| Illinois Tollway Base Sheet Revisions |

| Section M Base Sheet Drawings | |
| | Effective: 03-01-2019 |
| Drainage (DRN)-Series 600 | |

| Section M Base Sheet Drawings | |
|----------------------------------|------------------------------------------------------------------------------------------------------------------------------|
| M-DRN-600 | Outlet Control Structure Check Dam Details |

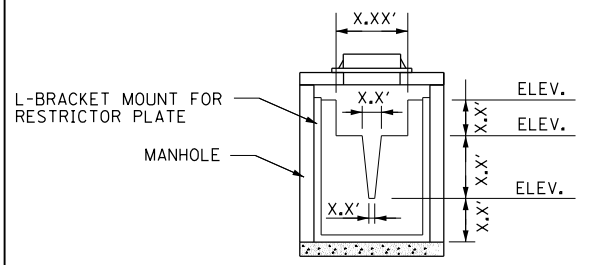
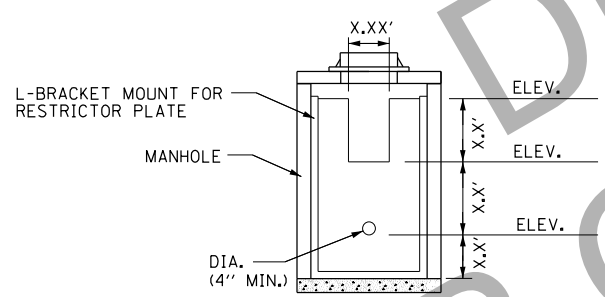
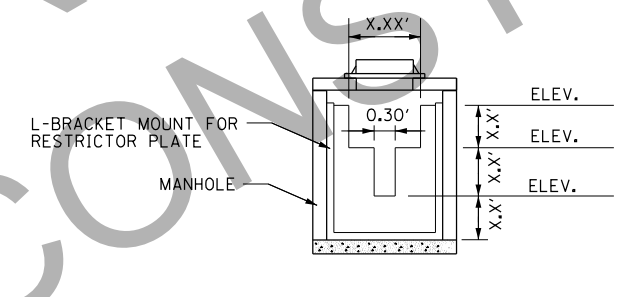
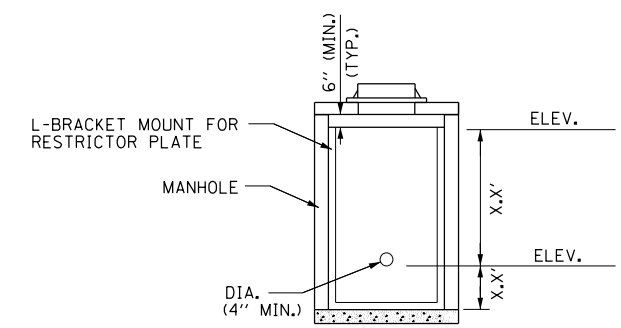
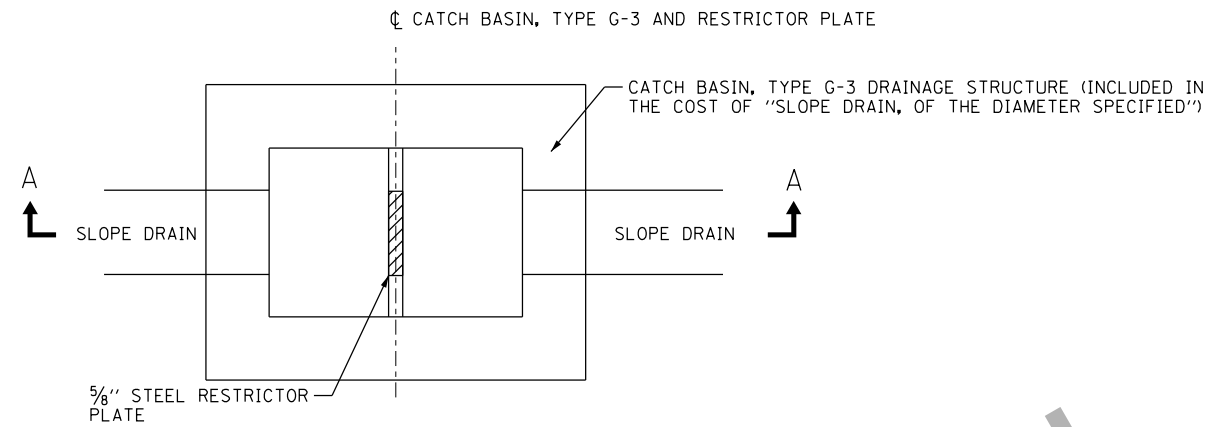
| Section M Base Sheet Drawings | |
|----------------------------------|------------------------------------------------------------------------------------------------------------------------------|
| | Added note to designer stating that steel angle bolts and fasteners shall be designed by the DSE and provided on this sheet. |
| | Added Note 2 giving option to contractor to use a concrete restrictor plate instead of steel. |
| | Changed call-outs from "Weir Plate" to "Restrictor Plate". |
| | Reworded Design Element from "Weir Plate-Release Rate" to "2-Year and 100-Year Release Rate". |
| | Restrictor Manhole was re-drawn to show two lids. |
| | Revised minimum clearance from top of restrictor plate to bottom of the manhole's top slab from 8" to 6". |

| Section M Base Sheet Drawings | |
|----------------------------------|------------------------------------------------------------------------------------------------------------------------------|
| M-DRN-601 | Slope Drain |

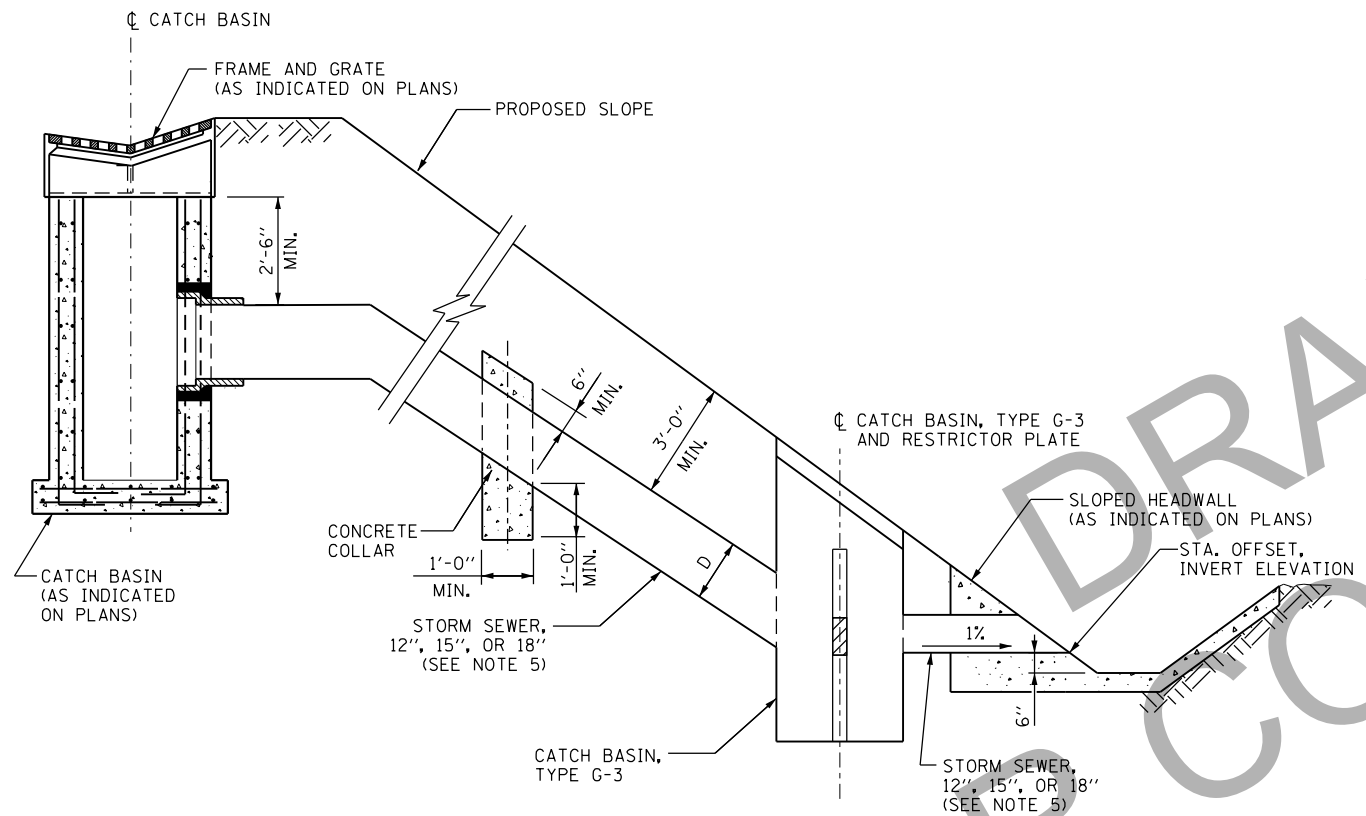
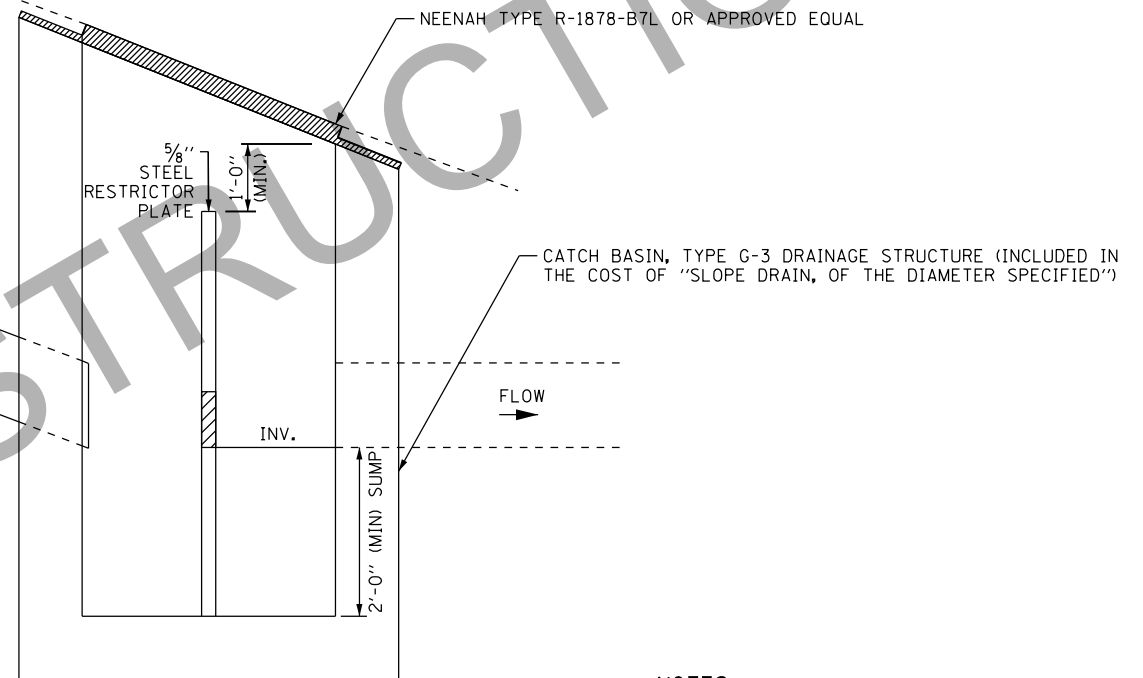
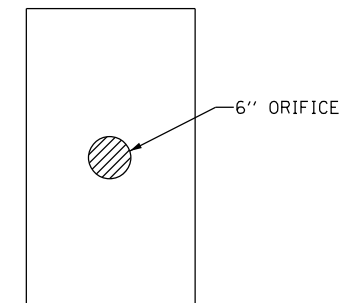
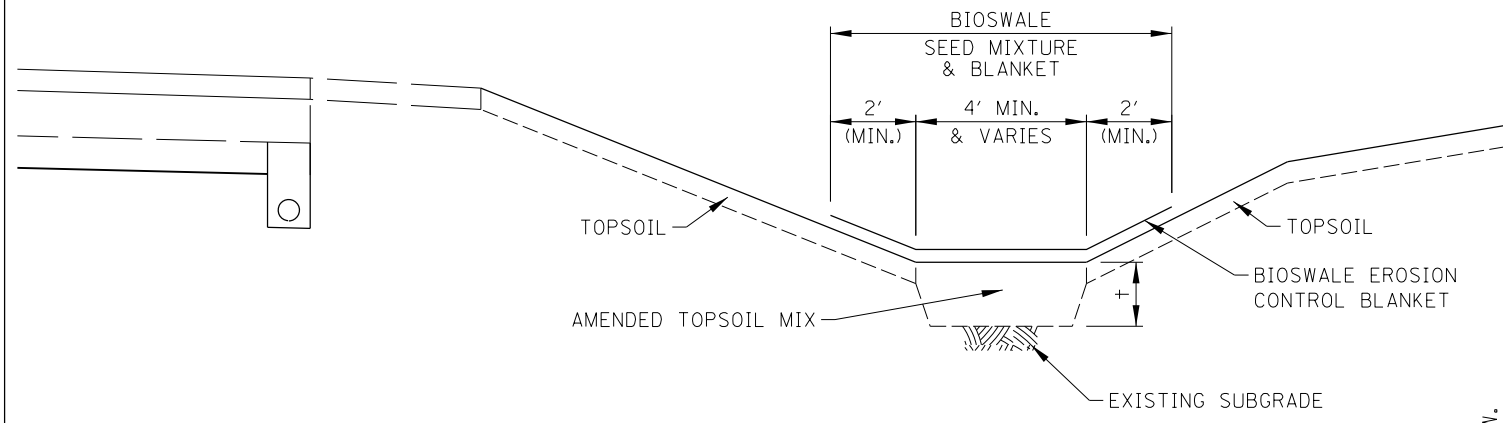
| Section M Base Sheet Drawings | |
|----------------------------------|------------------------------------------------------------------------------------------------------------------------------|
| | Added Note 5 stating what the allowable pipe materials are for slope drains. |
| | Provided a column for pipe diameter in the summary table. |
| | Added note to designer stating that steel angle bolts and fasteners shall be designed by the DSE and provided on this sheet. |
| | Changed call-outs from "Weir Plate" to "Restrictor Plate". |

| Section M Base Sheet Drawings | |
|----------------------------------|------------------------------------------------------------------------------------------------------------------------------|
| M-DRN-603 | Articulated Concrete Block Revetment System |

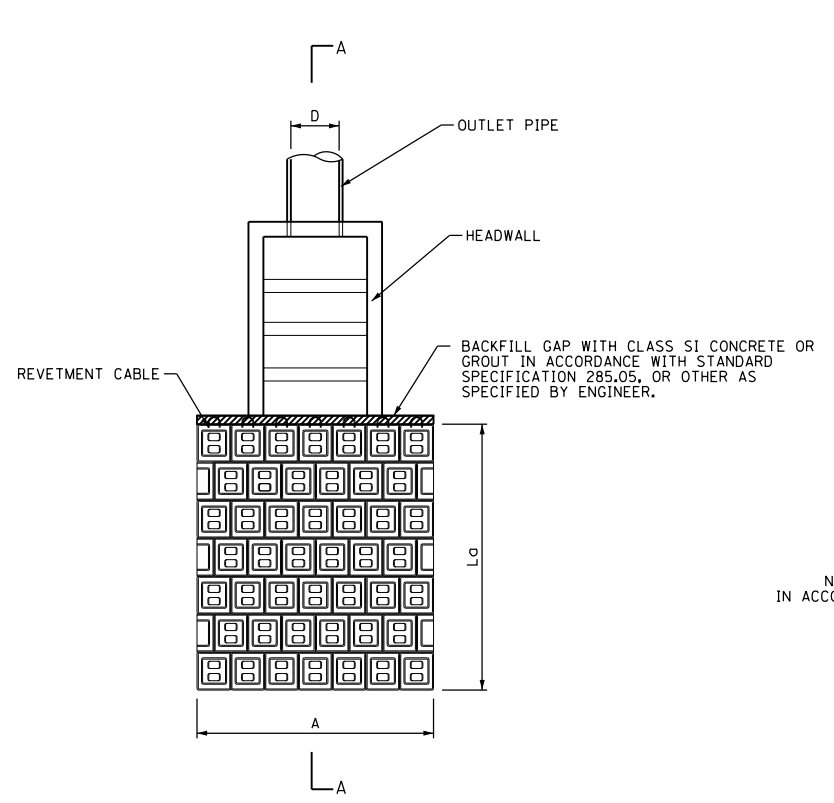
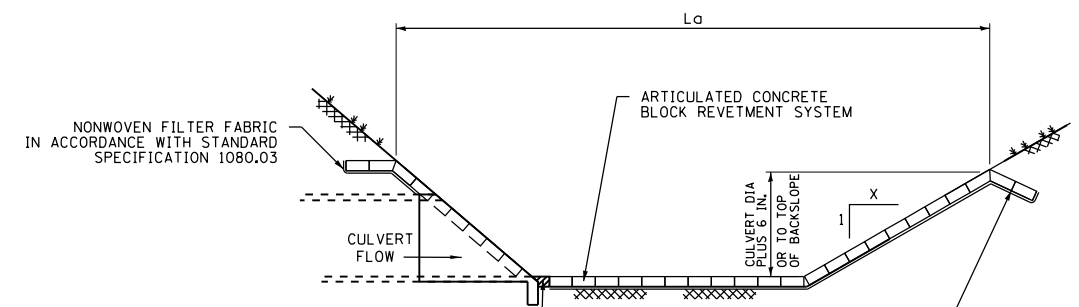
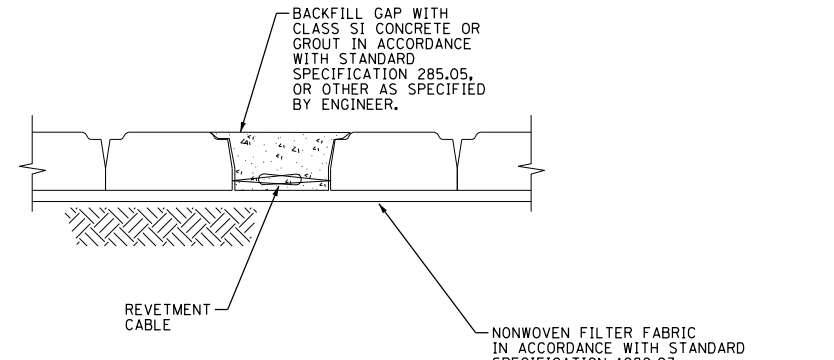
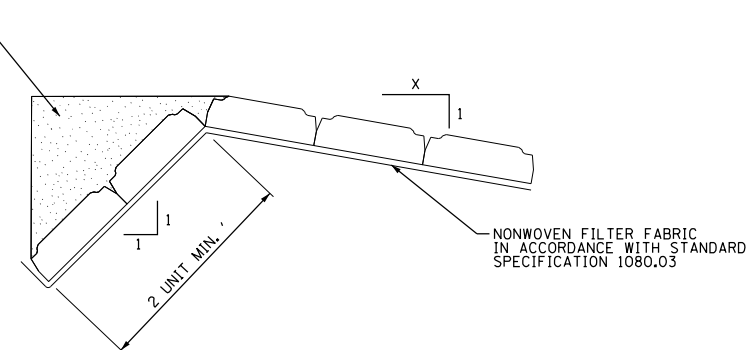
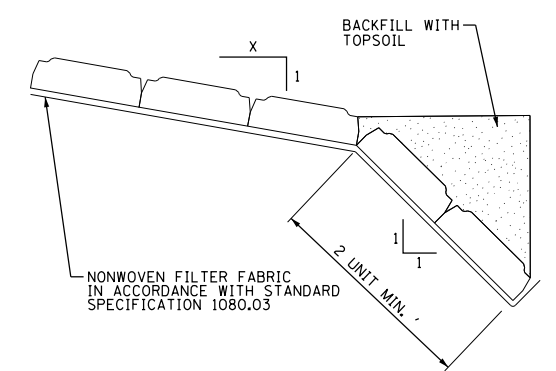
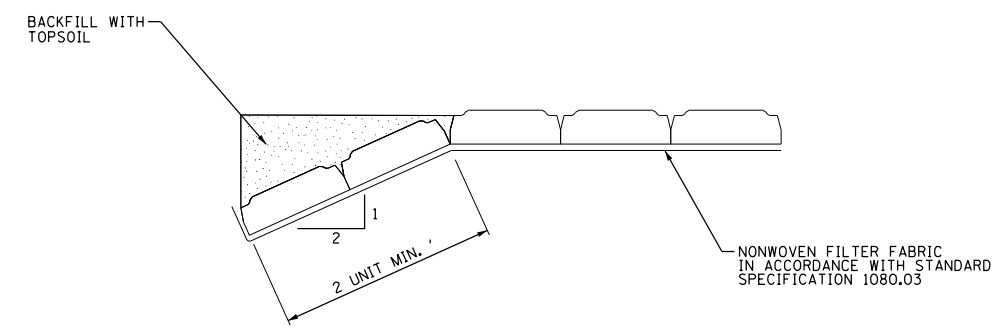
| Section M Base Sheet Drawings | |
|----------------------------------|------------------------------------------------------------------------------------------------------------------------------|
| | Added columns for "Pay Length" and "Pay Width" in the summary table. |
| | Added "Notes to Designer". |
| | Removed column for Block Configuration in the summary table as this information is provided in Note 1. |
| | Removed dimension "B". |
